## ADDENDUM NUMBER 03

project name:  
**NH Legislative Garage**  
 project address:  
 33 CAPITOL STREET  
 CONCORD, NH

Project name:  
**New Legislative Parking Garage**  
State Project Number: 81284-B  
Project Address:  
33 Capitol St.  
Concord, NH 03301

**1 FOUNDATION PLAN**  
SCALE: 3/32" = 1'-0"

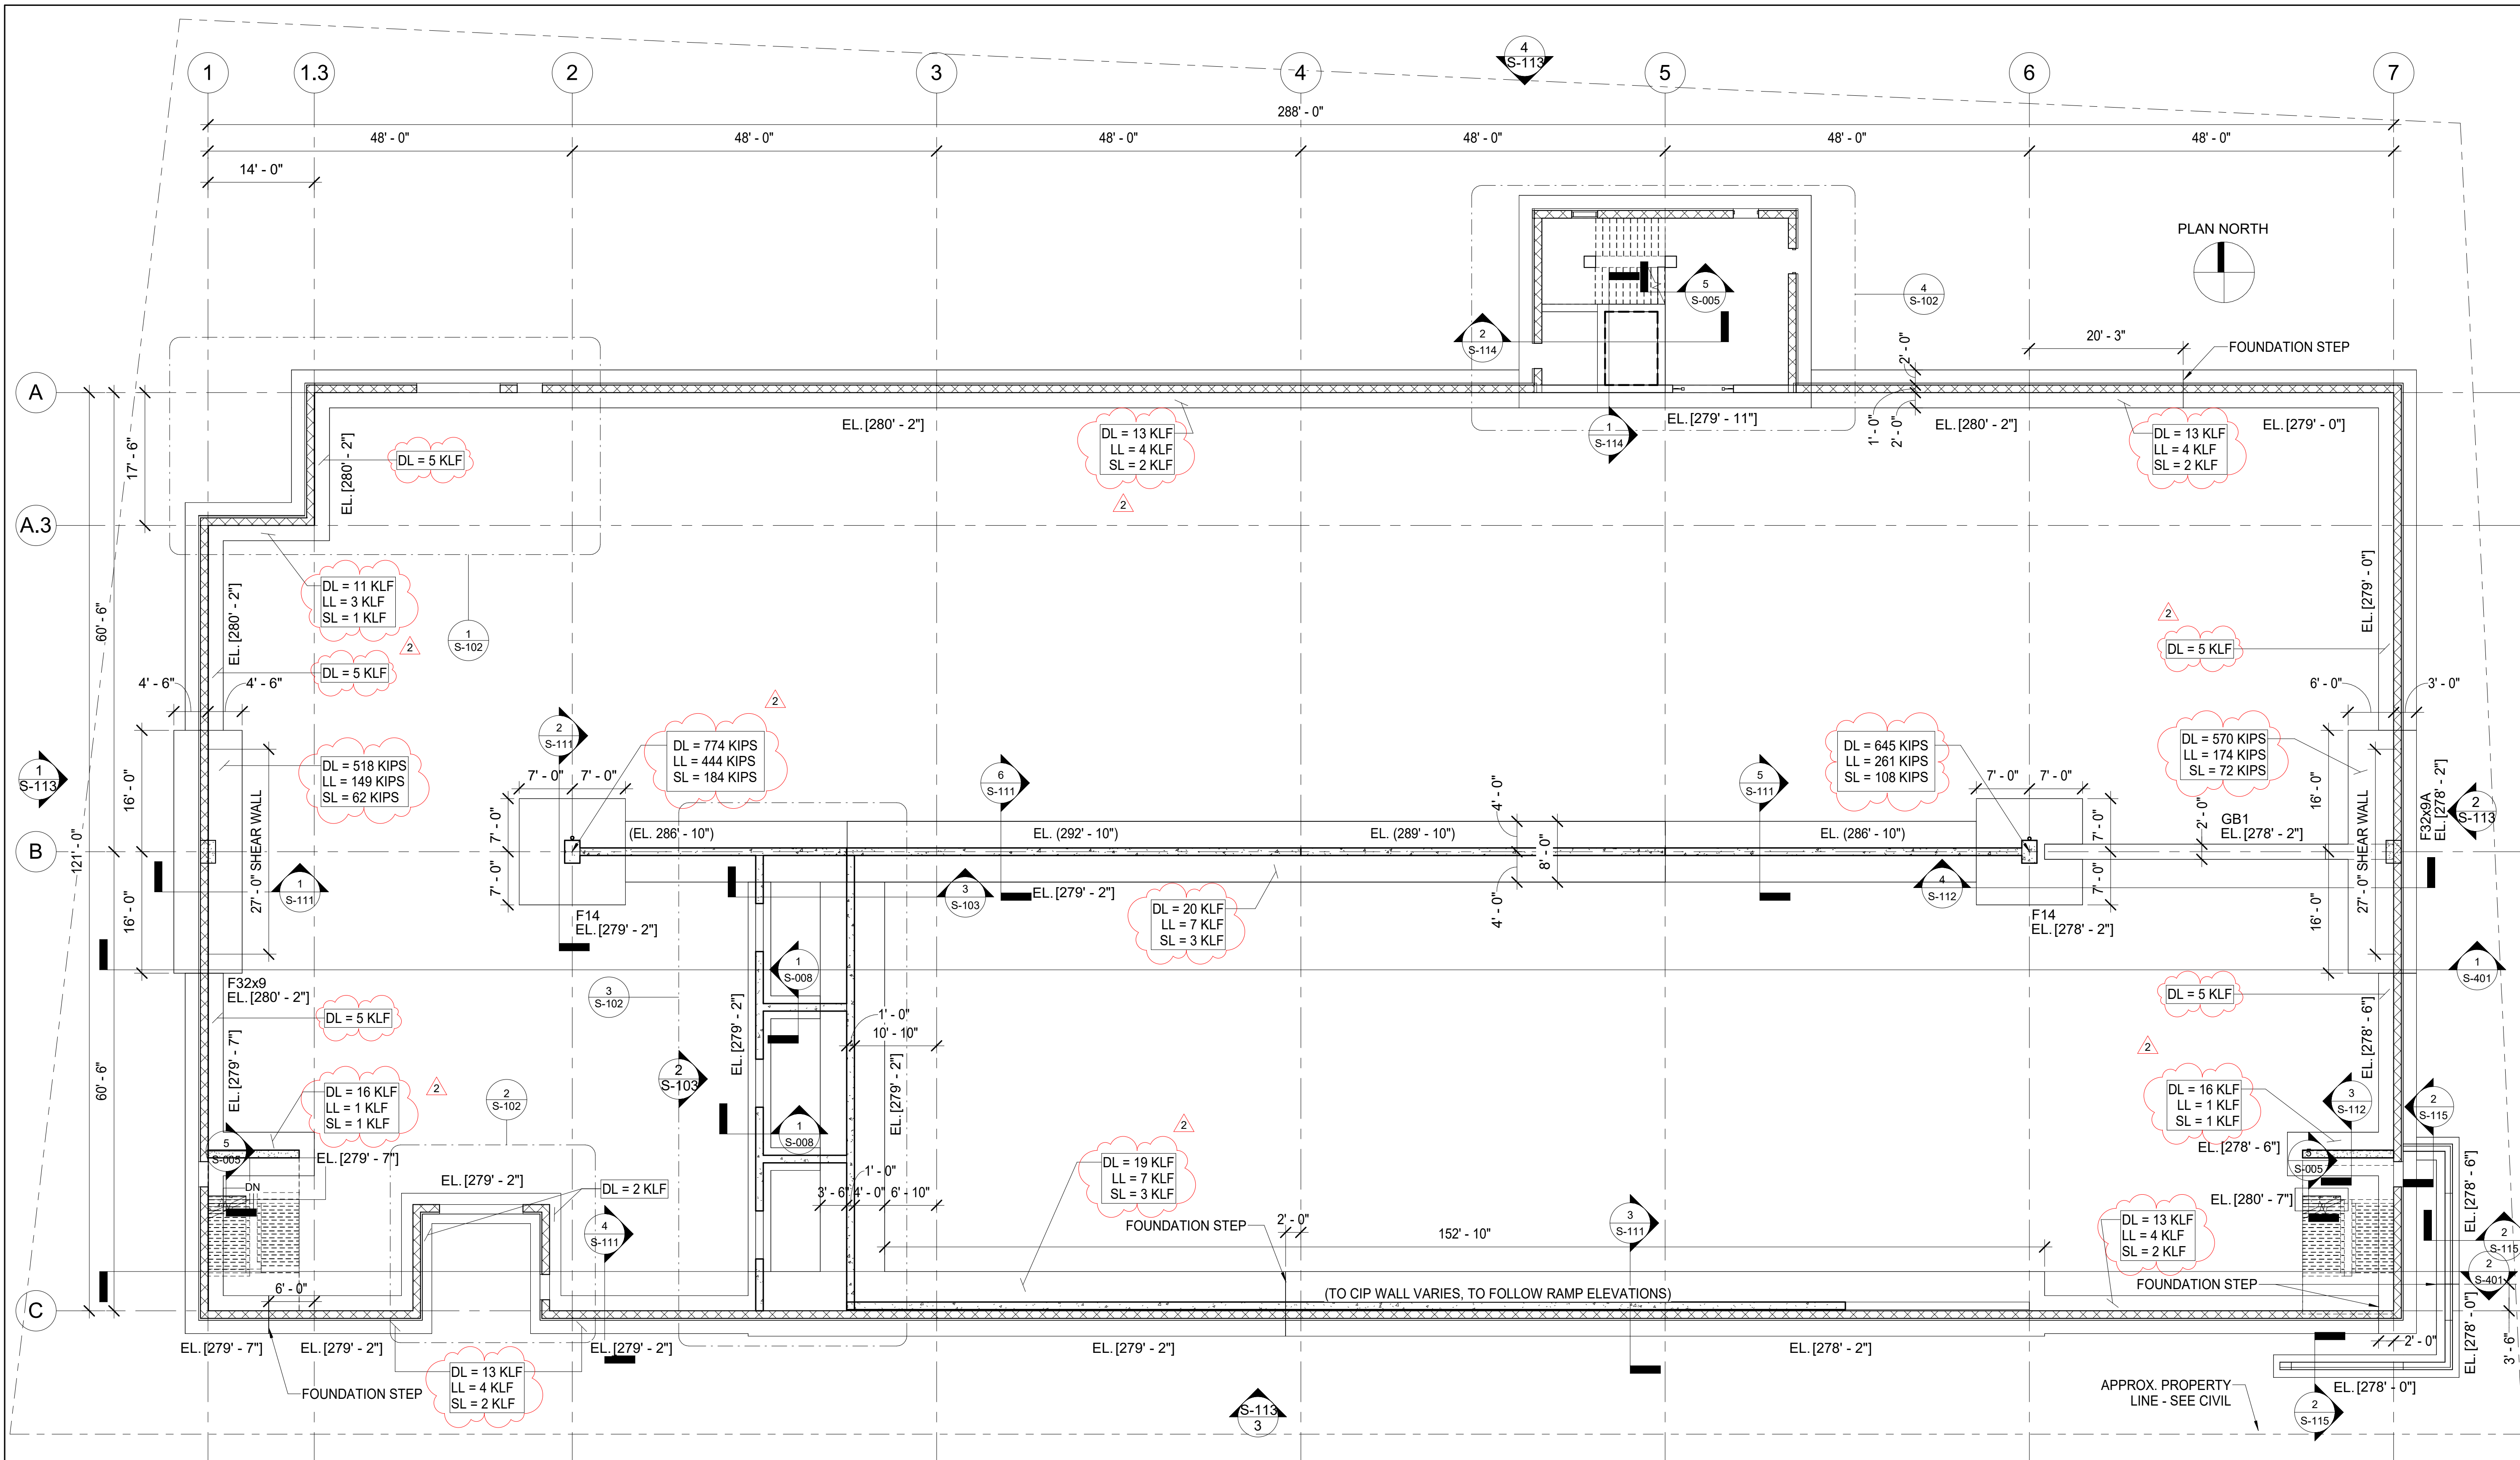
A. Ground improvement is only required beneath footings and not required under the slab.
4. Q: Factored loading provided on the foundation plan S-101 results in a contact pressure greater than 6,000 PSF (DL+LL+SL). Can confirmation be provided from the structural engineer that ground improvement can be designed for a maximum allowable bearing pressure of 6,000psf?

A. Revised unfactored loads have been provided on the revised S1.03 drawing.
